Change Order # 3 data.
Format (## / ## / ##) = (Previous page total / This Page total / Over all total)
Bid item 2: Ductile 14-16' deep: 0/0/0
Bid item 3: PVC 14-16' deep: 0/0/0
Bid item 4: CIPP: 0/389/389
Bid item 7: MH 10-12' deep: 0/0/0
Bid item 30: Inlet Protection: 0/3/3

TOWN OF LANDIS
SANITARY SEWER SYSTEM REHAB
ROWAN COUNTY, NORTH CAROLINA

DATE	BY	REV.	DESCRIPTION
9-22-2022	R. MOSS		PLAN AND PROFILE
SCALE: AS SHOWN			
DATE: 9-22-2022			
DRWN. BY: R. MOSS			
CHKD. BY: G. FLOWERS			
PROJECT NUMBER			
G20053.0			
DRAWING NO.		SHEET NO.	
S-4		8

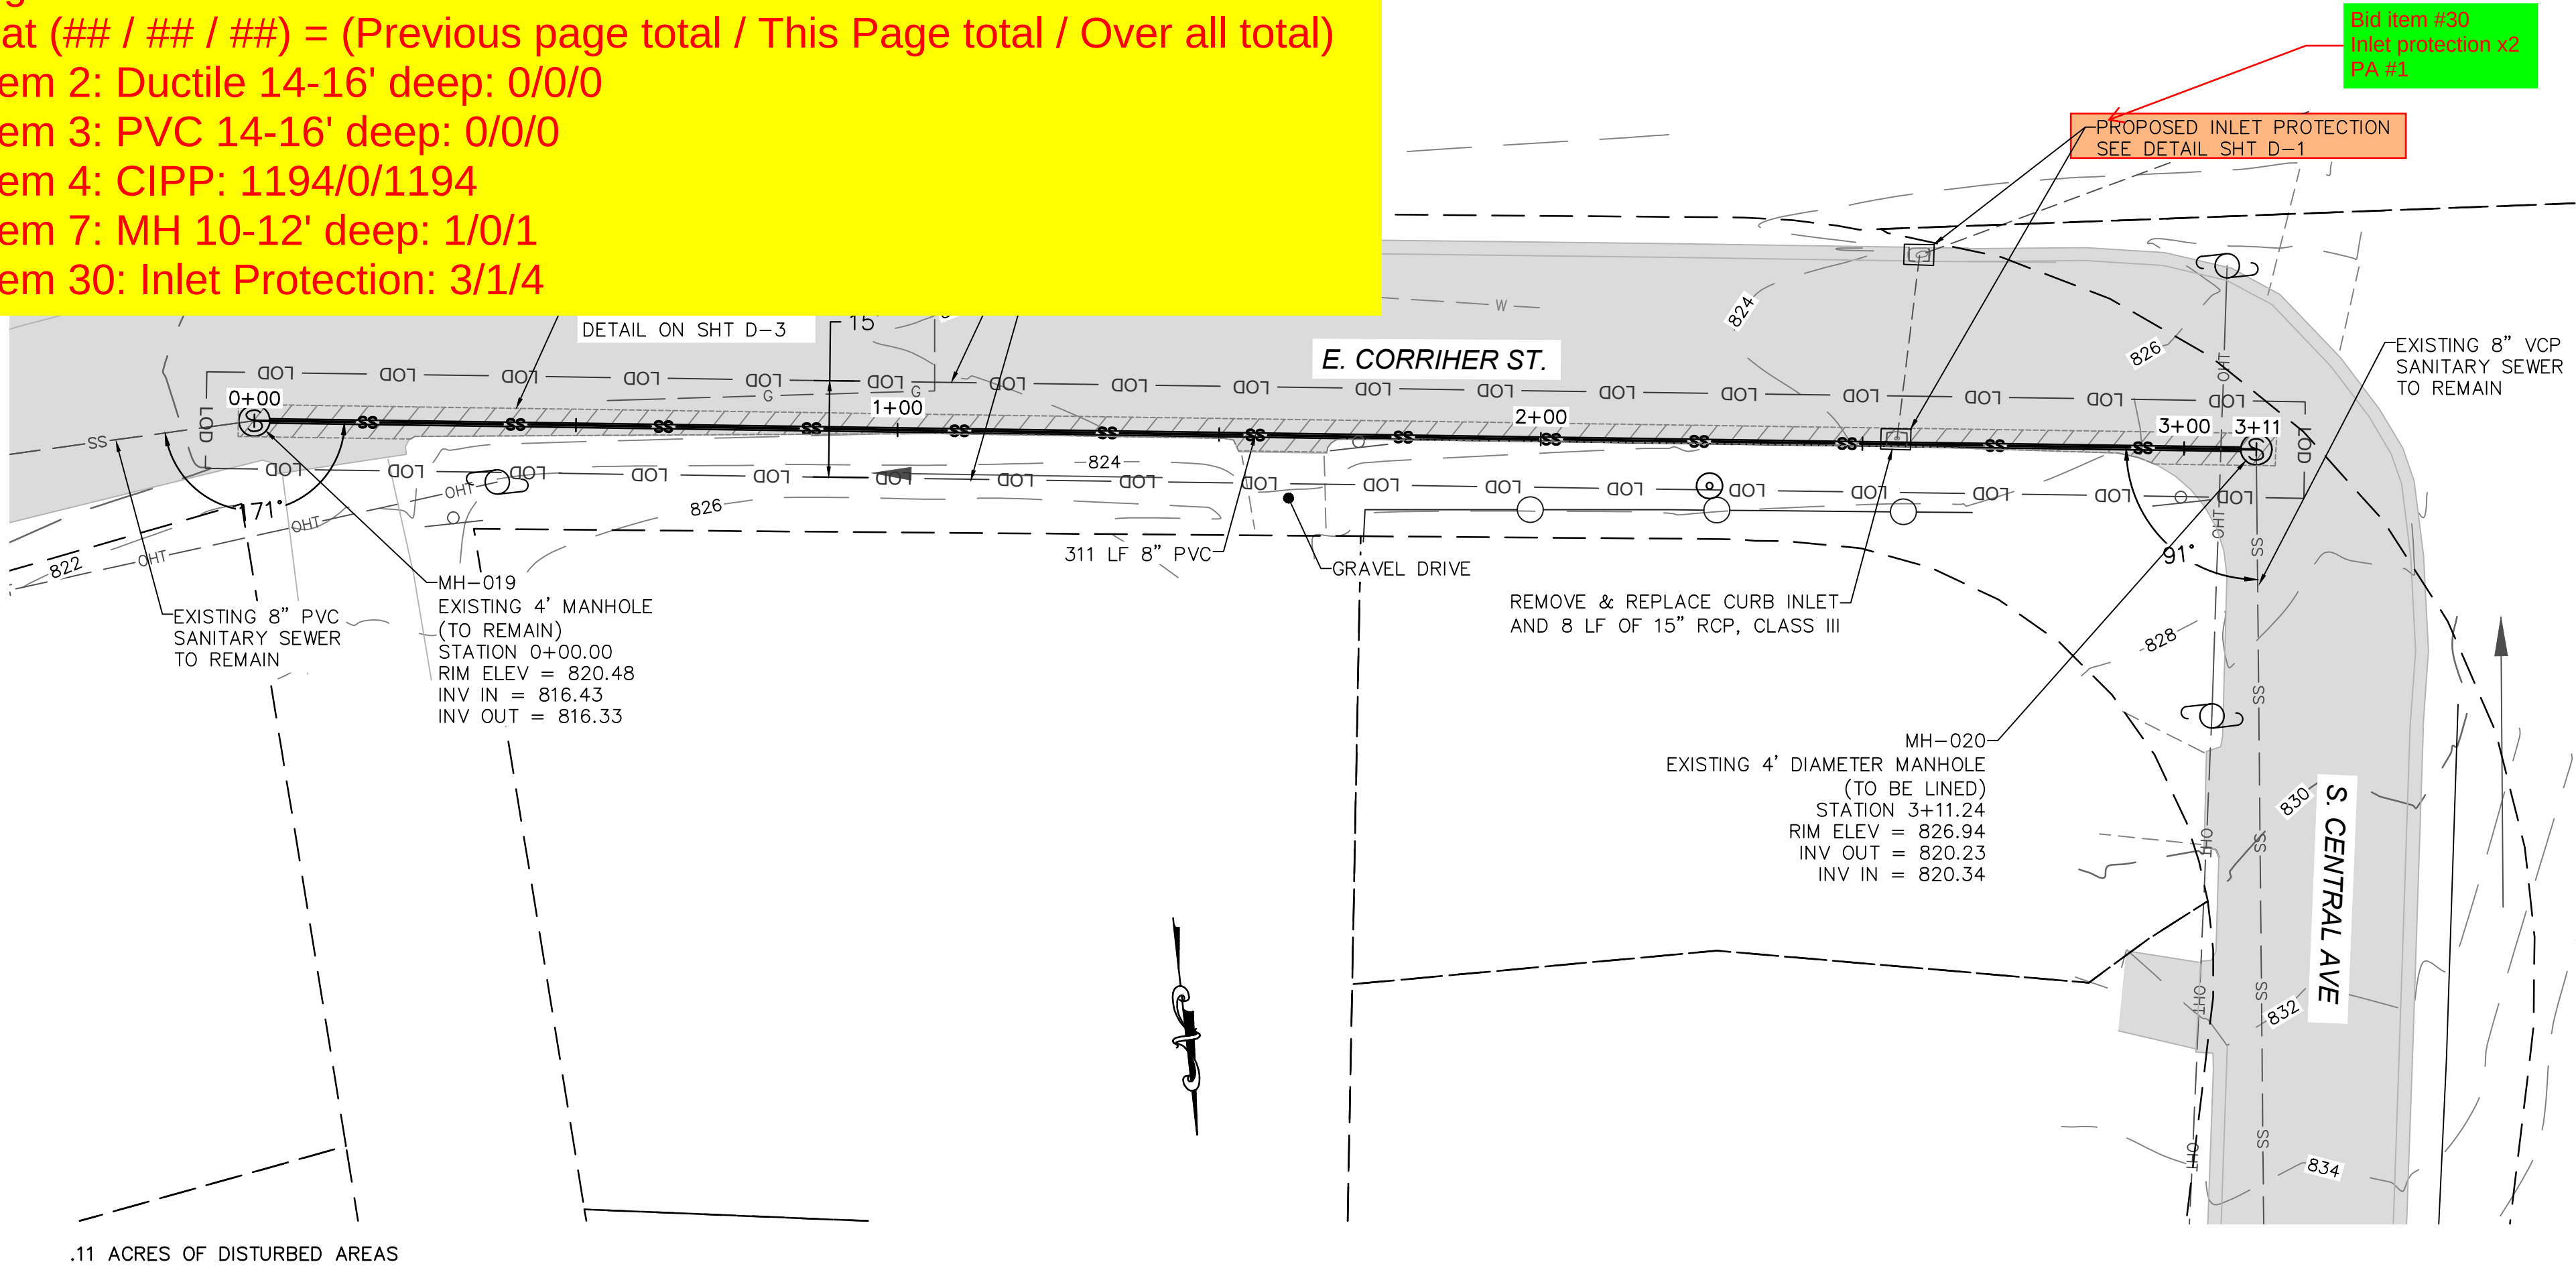
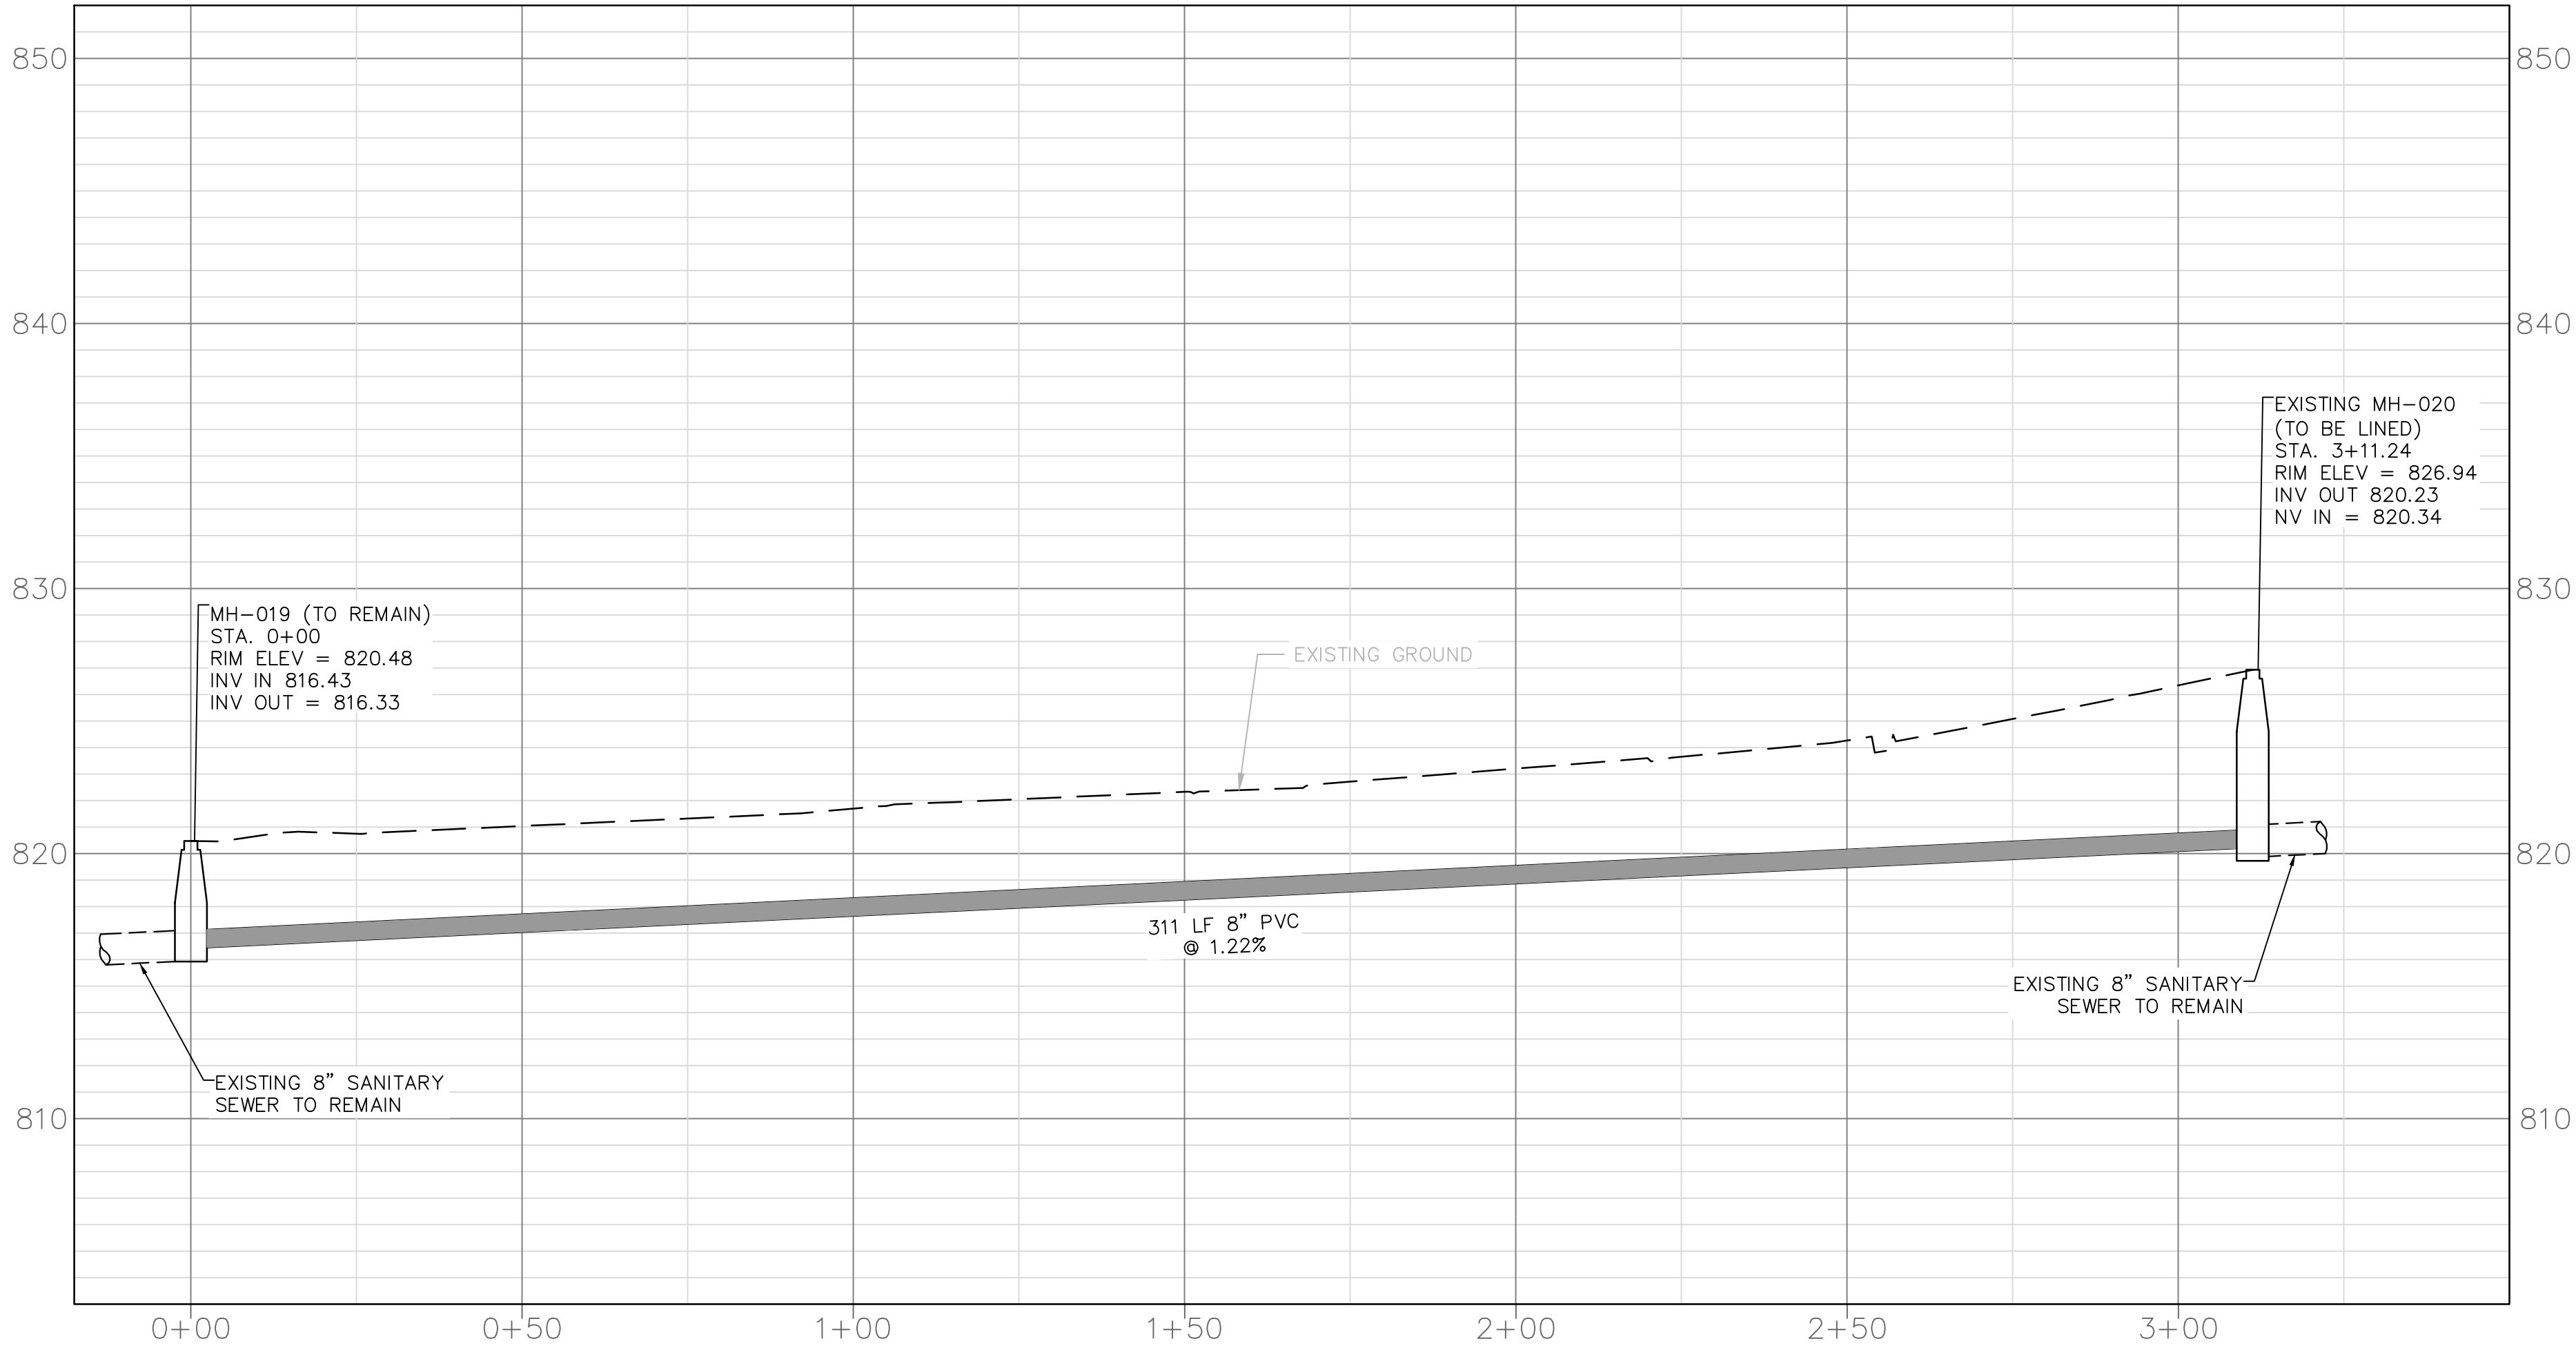
Change Order # 3 data.
Format (## / ## / ##) = (Previous page total / This Page total / Over all total)
Bid item 2: Ductile 14-16' deep: 0/0/0
Bid item 3: PVC 14-16' deep: 0/0/0
Bid item 4: CIPP: 1194/0/1194
Bid item 7: MH 10-12' deep: 1/0/1
Bid item 30: Inlet Protection: 3/1/4

SCALE: AS SHOWN
DATE: 9-22-2022
DRWN. BY: R. MOSS
CHKD. BY: G. FLOWERS
PROJECT NUMBER
G20053.0
DRAWING NO. S-10
SHEET NO. 14

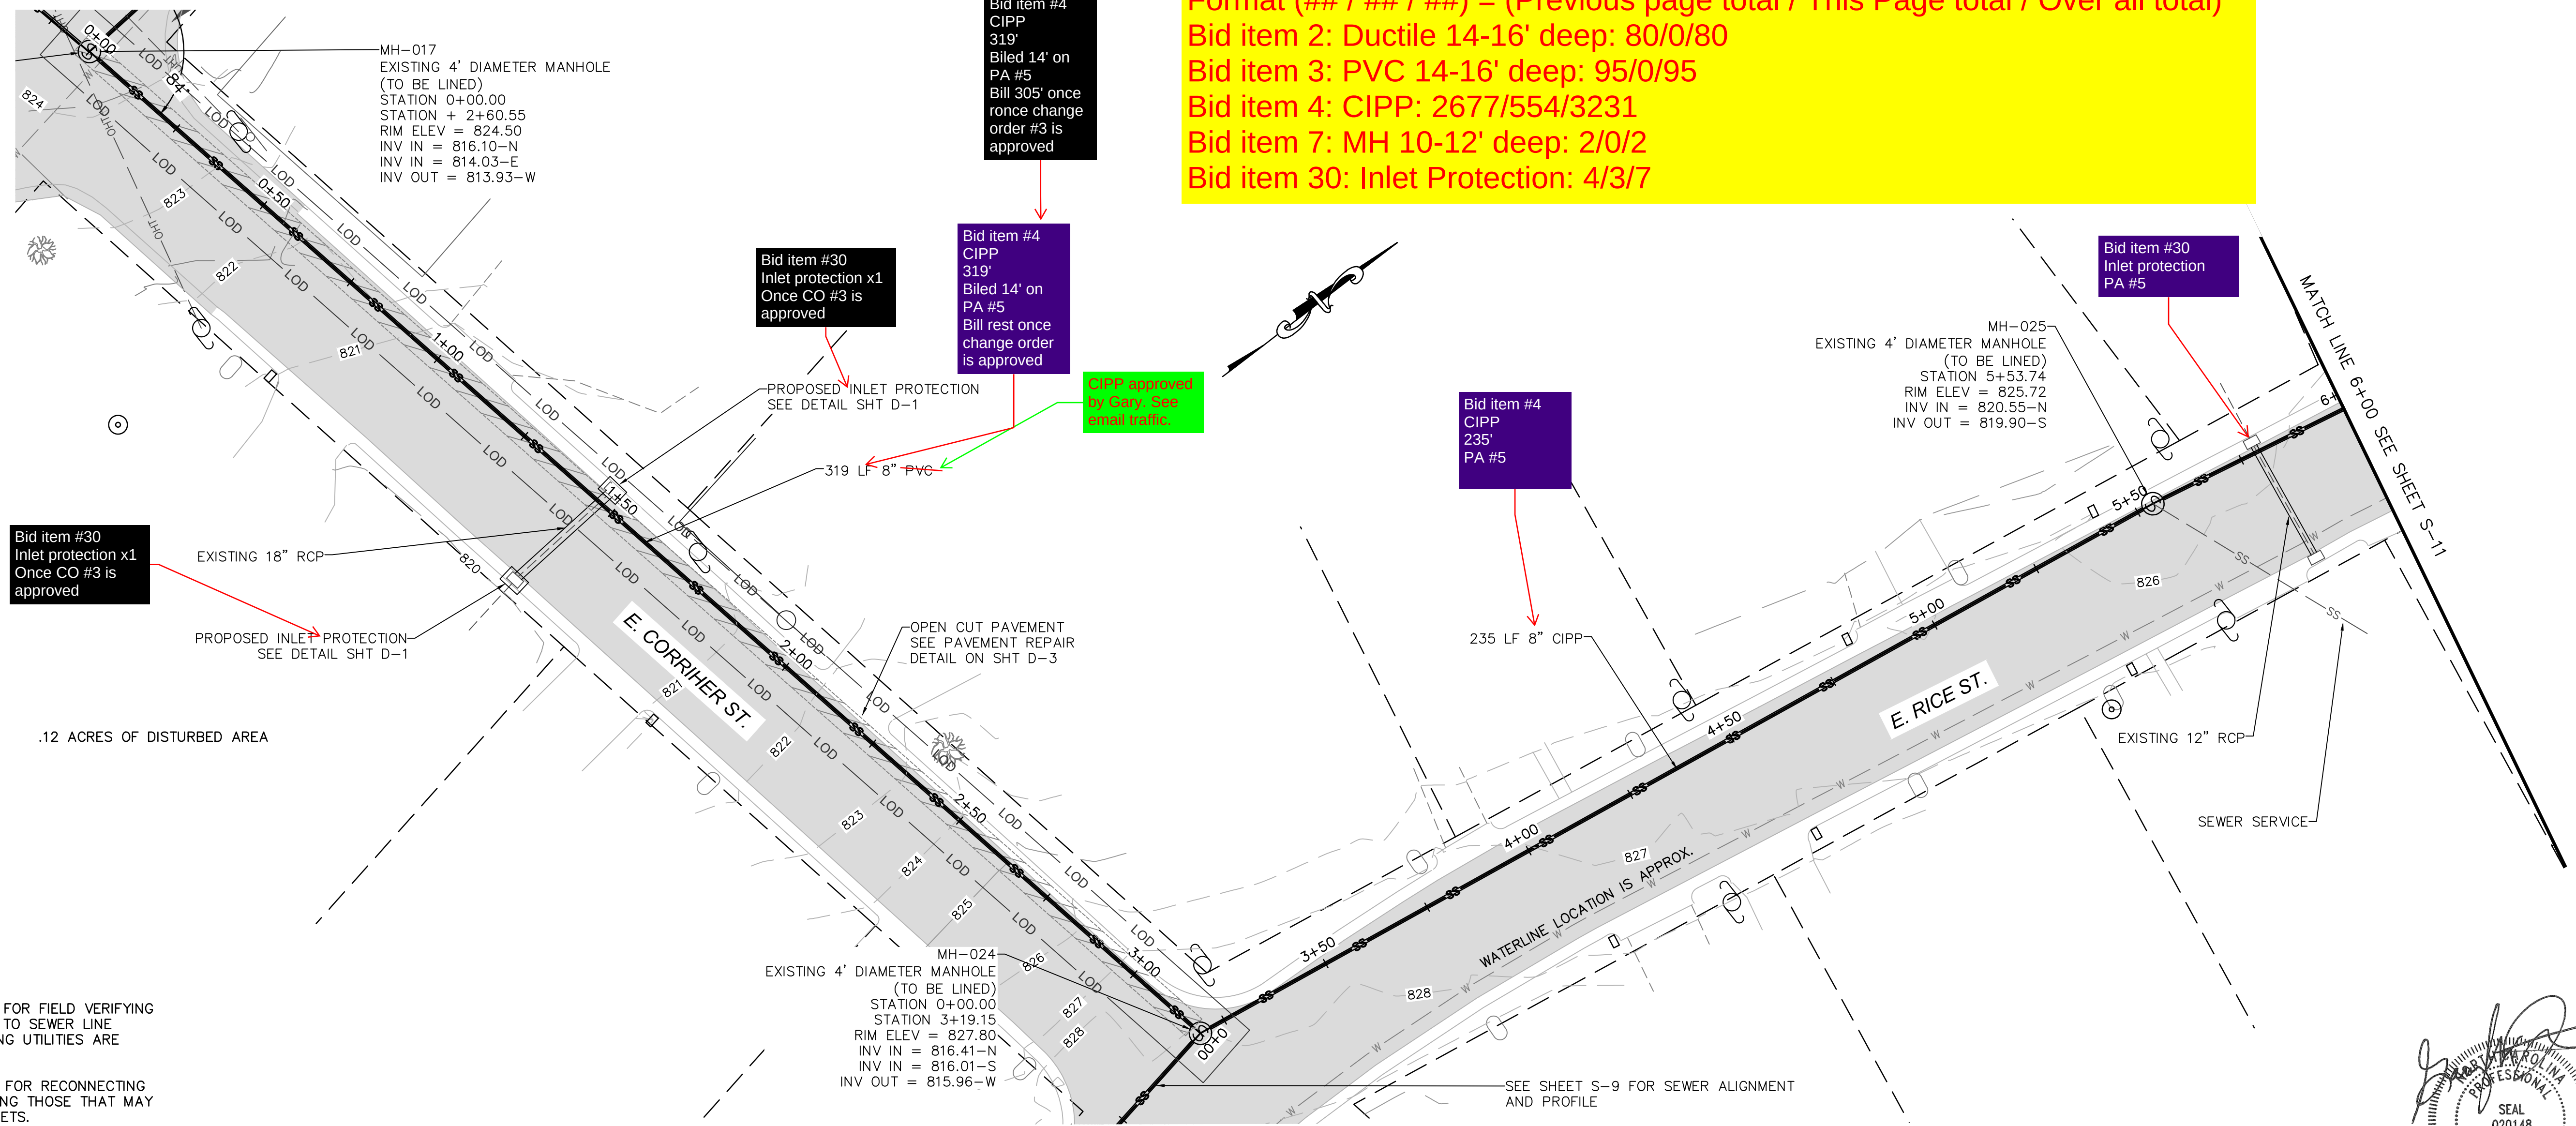
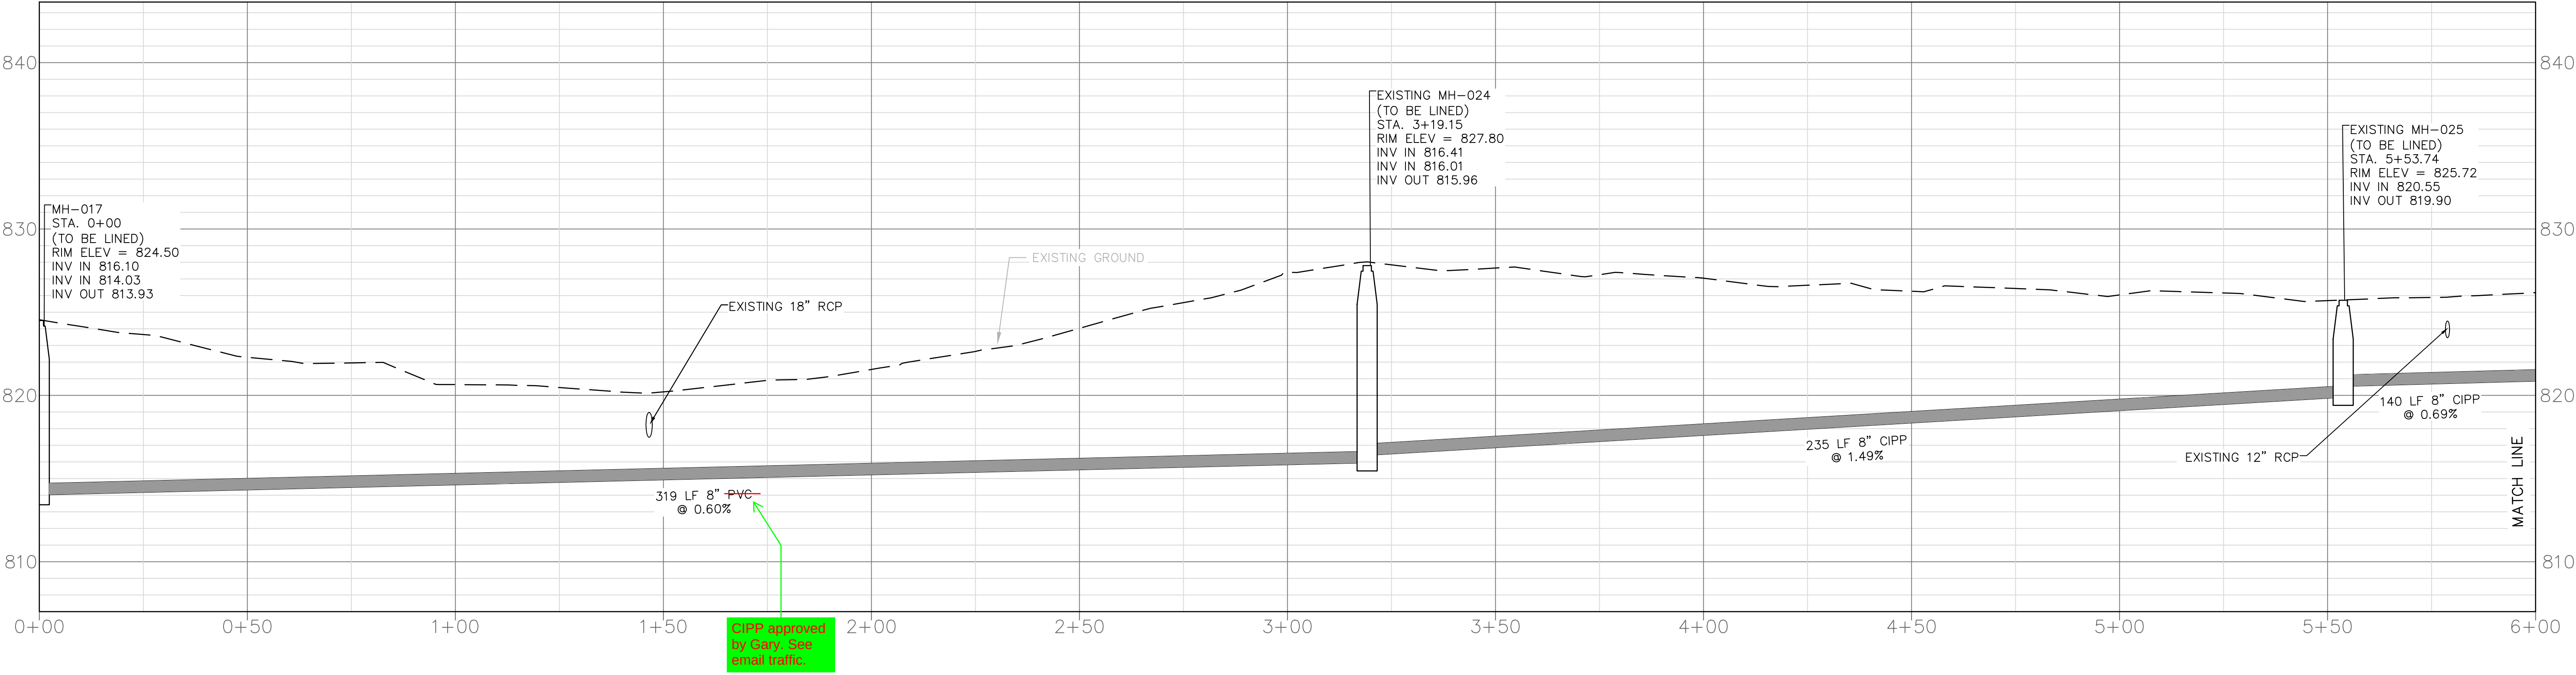
Change Order # 3 data.
Format (## / ## / ##) = (Previous page total / This Page total / Over all total)
Bid item 2: Ductile 14-16' deep: 80/0/80
Bid item 3: PVC 14-16' deep: 95/0/95
Bid item 4: CIPP: 2677/554/3231
Bid item 7: MH 10-12' deep: 2/0/2
Bid item 30: Inlet Protection: 4/3/7
